Stair flip study · the main stair turned round: start and arrival at the NORTH end, next to the lift · Taif / Palm House V8.0 (work) · STUDY ONLY

ADOPTED 2 Nov 2026 (owner): option B, the freed landing as F-b, the balustrade, the store door onto the riwaq, the half-landing window, the entrance side light, the entry cupboard removed; applied to the design files. Owner's idea, 1 Nov 2026 · the same well (2.75 × 5.7 on axes, 2.525 × 5.50 clear), the same 22 risers × 0.164 / goings 0.28, flights 1.21 clear · nothing in the design files changes until the owner decides · all sizes assumed

1 · The two options on the ground floor

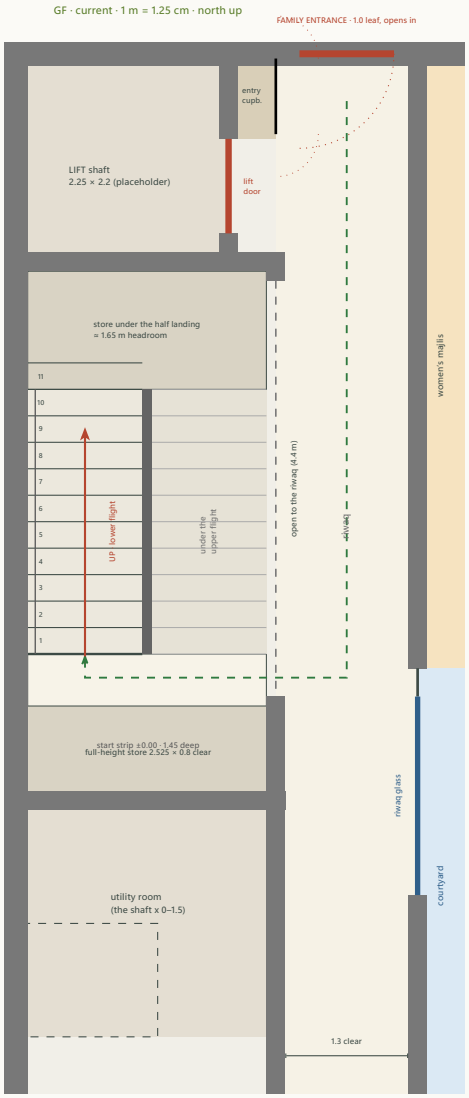
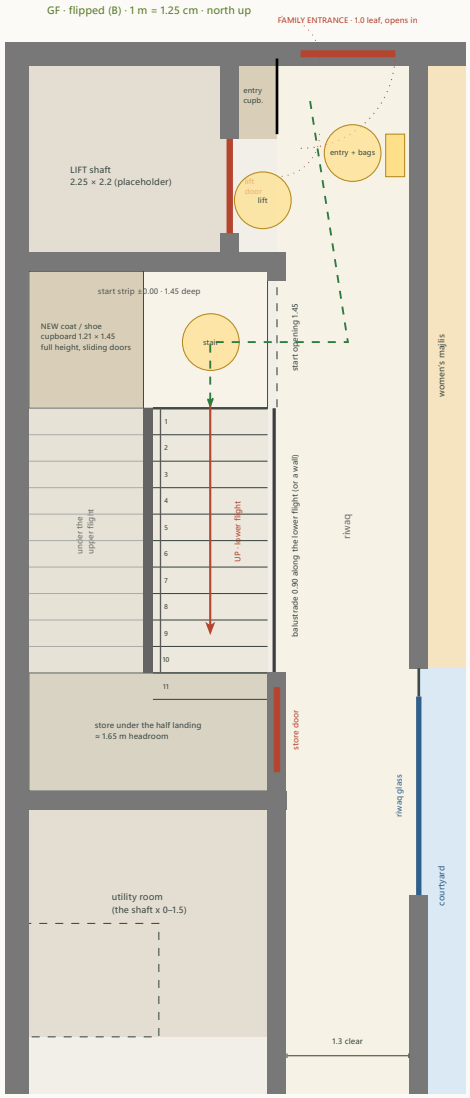
- **Current:** the lower flight on the **west** half starts at the **south** end (first riser y 6.35); the person comes along the riwaq, enters the well through its open east side (4.4 m open) and turns west onto the flight; in front of the first riser only **0.55 m** before the full-height store's wall (the start is really made from the side, under the upper flight's high end). Half landing at the north end (+1.80, a 1.65 m store below it, opening east onto the riwaq); the full-height store 2.525 × 0.8 clear at the south end.

- **Flipped (B, recommended of the two flips):** the lower flight on the **east** half starts at the **north** end (first riser y 3.75), **straight off the lobby**: a 1.45 m opening in the x 2.75 line between the lift notch and the flight, a start strip 1.45 m deep in front of the first riser. The lower flight rises along the riwaq side (a 0.90 balustrade on the riwaq, or a wall: the owner's choice); the half landing at the south end with its 1.65 m store (door onto the riwaq at y 6.7–7.6, in front of the courtyard glass; or into the utility room). The **west half of the start strip** (1.21 × 1.45, full height) becomes a **coat / shoe cupboard** beside the family entrance (sliding doors onto the strip).

- **Flipped (A):** the mirror image only (the lower flight stays west): the person crosses the whole strip to the far half before climbing; no cupboard. Not recommended; everything else below holds for both.

2 · Congestion test at the flipped start (drawn)

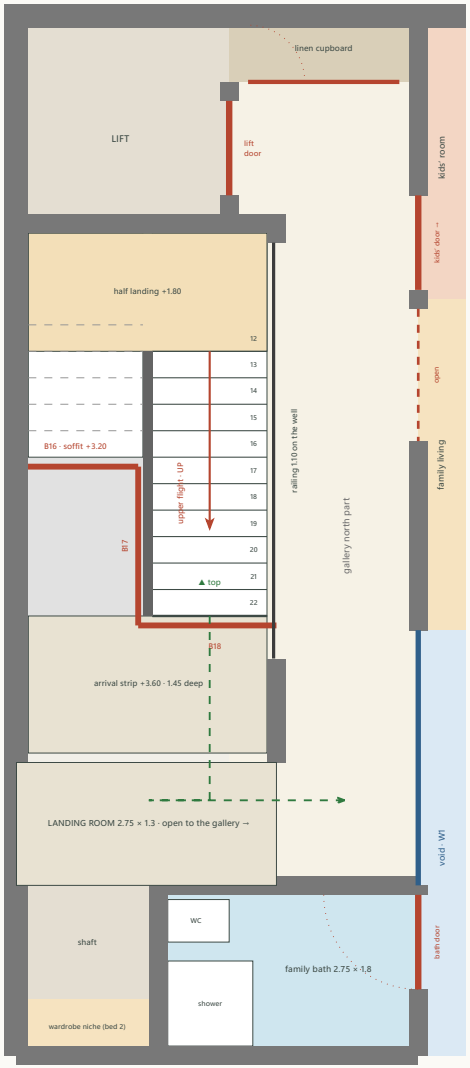
Three people at once: **one waiting for the lift** in the 0.50 m notch in front of its sliding door, **one coming in with bags** inside the family entrance's 1.0 m swing, **one starting up the stair** on the start strip, with the **entry cupboard's two 0.45 leaves open** into the lobby. Clear widths, not axes: the lobby **1.3 m** between the lift / cupboard wall face and the women's majlis wall face (the notch adds 0.5 m at y 0.9–2.2); the start opening **1.45 m**; the first riser **1.21 m** wide; the entrance **0.9 m** clear. The three stand in three separate zones along the lobby (y 0–1.0 the door swing, y 0.9–2.2 the lift notch, y 2.3–3.75 the start strip); the stair starter passes 0.3 m south of the lift waiter and never crosses the entrance swing: **OK**. Two people can pass in the 1.30 m lobby (0.60 + 0.60 + 0.10) but a person with two bags blocks it for a moment, as today. **Furniture up the stair:** the 90° turn from the 1.30 lobby through the 1.45 opening onto the 1.21 flight is a tight but normal house stair turn; the current start (0.55 m strip, sideways) is worse.

FF · current · 1 m = 1.25 cm · white = opening · grey = slab

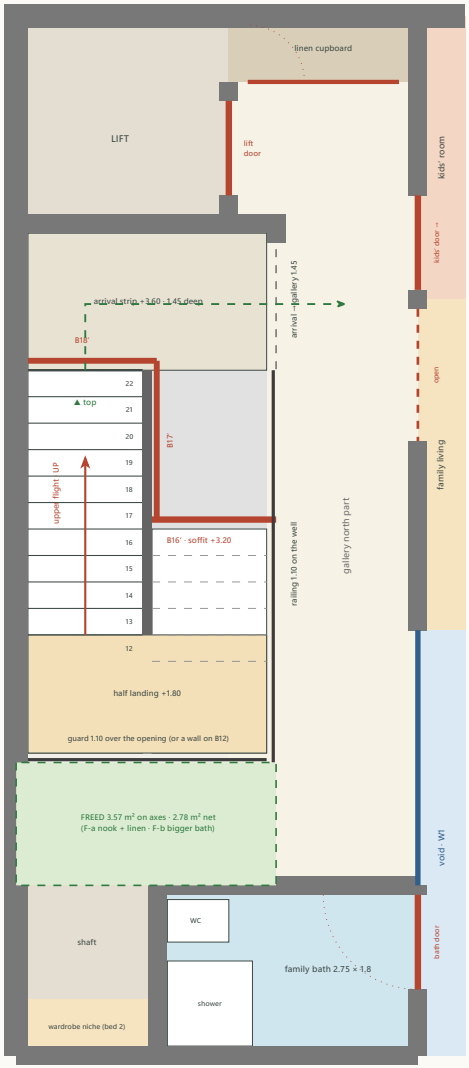
- **Current:** the upper flight (east half) lands at +3.60 on the arrival strip (y 6.35–7.8), then the **landing room** (2.75 × 1.3, y 7.9–9.2) and east into the gallery; the bedrooms and the family bath are at hand, the kids' room, the living and the lift are 6–9 m north along the gallery.

- **Flipped (B):** the upper flight (west half) lands on the arrival strip at the **north** end (y 2.3–3.75); the strip opens east onto the gallery's north part (1.45 m), **0.10 m south of the lift notch**: the lift's first-floor door, the linen cupboard (its leaves swing south, 0.6 m), the kids' room door (opens into the room) and the family living's opening are all within 1–3 m. The gallery's north part (1.30 clear) carries the arrival traffic as it carries the lift's today; the linen leaves and the lift door are 1.0 m north of the arrival: no clash. The railing on the well runs from the arrival (y 3.75) to the south wall; the landing room is **freed** (§ 5).

- **Current (studies/structure.typ):** an L-shaped opening ≈ 8.2 m²: the west half open from the north wall to B16 (y 4.85), the east half open to B18 (y 6.45); B16 (0.20 × 0.40, soffit +3.20) from the west wall to B17; B17 (x 1.29, on the lower flight's side of the split) from B16 to B18; B18 (y 6.45) from B17 to the riwaq-line beam B10 (x 2.75).

- **Flipped (B):** the **same opening turned round** (≈ 8.2 m²): the east half open from B16′ (y 5.33) to the south wall, the west half from B18′ (y 3.65) to the south wall. **B16′** (y 5.33) from the riwaq-line beam B10 to B17′; **B17′** (x 1.49, on the east, lower flight's side of the split: never over the upper flight) from B16′ to B18′; **B18′** (y 3.65, the arrival edge) from the west wall to B17′. The same zigzag, mirrored: one beam-on-beam junction at each end of B17′, the torsion the engineer's; B18′ now bears on the west wall (as B16 does today) and B16′ on B10 (as B18 does today). **Neither better nor worse** for the structure: the spans (1.3–1.6 m) and the bearings are the same kind. **Not verified.**

- **Slab edges:** the arrival strip (1.45 × 2.525) spans between the north wall beam B11 (y 2.2) and B18′; over the lower flight's first six treads the slab spans from B18′ to B16′ (1.6 m) between B10 and B17′. The guard round the opening: the railing on x 2.75 from the arrival south to y 7.9, the well's south wall line y 7.9 (a 1.10 guard or a wall on B12), the upper flight's balustrade on the split.

FF · flipped (B) · 1 m = 1.25 cm · white = opening · grey = slab

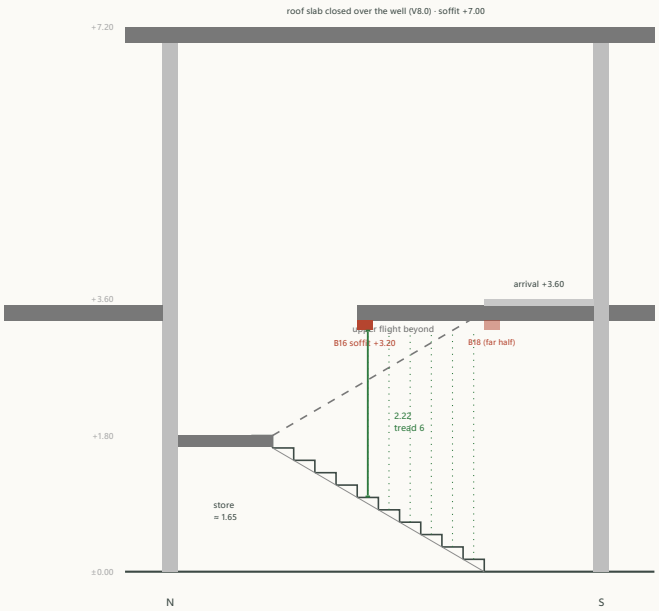
5 · The freed landing: what it can really become

- **Gross** 3.57 m² on axes (2.75 × 1.3). **Net** between finished faces, keeping the gallery connection on its east side and a guard or wall on the opening (y 7.9): **2.53 × 1.1 = 2.78 m²**.

- **F-a · gallery nook + linen:** leave it open to the gallery with a 1.10 guard over the well; a **0.6 m linen / towel cupboard** along the west wall (0.6 × 2.53 = 1.52 m², next to the family bath's door); the rest (1.92 × 1.1) widens the gallery to a **2.9 m deep nook** in front of the bath door: a bench, the laundry basket, a window on the west wall (y 8.0–9.1). Net storage gained 1.52 m²; the gallery is not wider where it matters (the 1.30 m north part stays 1.30).

- **F-b · a larger family bath (recommended):** a wall on y 7.9 (on B12) and the bath's north wall y 9.2 opened: the bath becomes an **L of 4.95 + 3.57 = 8.52 m² on axes** (≈ 6.82 m² clear) with its door where it is (4.25, y 9.3–10.3): a **separate WC compartment** 1.3 × 1.1 at the north-west corner next to the shaft (the stack is right there: the WC drains to the x 1.5 shaft as today), the shower and a **second basin** for the two children, the linen in the compartment's wall. Net usable gain ≈ 2.78 m²: one WC door more than today (two children at the same time), nothing lost. The family bath serves bedrooms 1 and 2 and the living; this also answers part of the review's next item (bedroom 1's bathroom route: no nearer, but a bath with two compartments).

Headroom · a section along the lower flight for each option · the slab 0.2 thick (soffit +3.32), the trimmers 0.20 × 0.4 (soffit +3.20), the finish 0.08 · over the full walking width of every tread

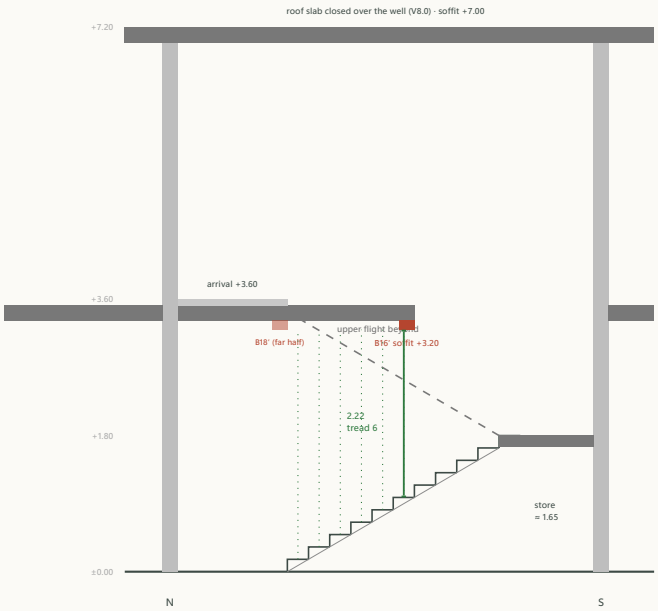
current · section along the lower flight, looking east · 1 m = 1 cm

flipped (B) · section along the lower flight, looking east · 1 m = 1 cm

The upper flight, the half landing and the arrival are under the open well (the roof slab's soffit +7.00): ≥ 3.4 m. Minimum of this option: **2.22 m** at tread 6 under the trimmer, across the whole 1.21 m width (the trimmer spans the half); B17 over the inner 0.10 strip of treads 1–5: ≥ 2.38 m.

The upper flight, the half landing and the arrival are under the open well (the roof slab's soffit +7.00): ≥ 3.4 m. Minimum of this option: **2.22 m** at tread 6 under the trimmer, across the whole 1.21 m width (the trimmer spans the half); B17′ over the inner 0.10 strip of treads 1–5: ≥ 2.38 m.

Verdict on the headroom: identical in both options (**2.22 m** at tread 6 under the trimmer, 2.83 m at tread 3 under the slab; ≥ 2.10 required, the 2.20 aim just met) because the flip mirrors the geometry: the trimmers sit in the same places relative to the treads. **The flip neither improves nor worsens the trimmers.** What would improve both: trimmers 0.20 × **0.30** (soffit +3.30 → **2.32 m** at tread 6) if the engineer accepts a 0.30 depth for the 1.3–1.6 m spans, or the slab edge moved one tread (the opening 0.28 m longer, ≈ 0.35 m² more void, tread 6 under open sky → the minimum moves to tread 5: 2.38 m). Both options can take either. The walls' handrails run the full flights (0.08 off the walls); the central handrail on the 0.10 split.

- **Conditions:** (1) a glazed panel / side light in the family entrance (or a lobby window) and a **west window at the half landing** so the start and the well are not dark; (2) the **balustrade** along the lower flight on the riwaq side, 0.90 m, black steel in the design language (not a wall), so the riwaq keeps its width of view; (3) the freed landing as **F-b, the two-compartment family bath** (the WC by the shaft, a second basin), or F-a if the owner prefers a nook; (4) the half-landing store's door onto the riwaq (household) — or into the utility room (service), the owner's choice; (5) the headroom improvement, open to both: ask the engineer for **0.30 trimmers** (2.32 m at tread 6) before the slab is detailed.
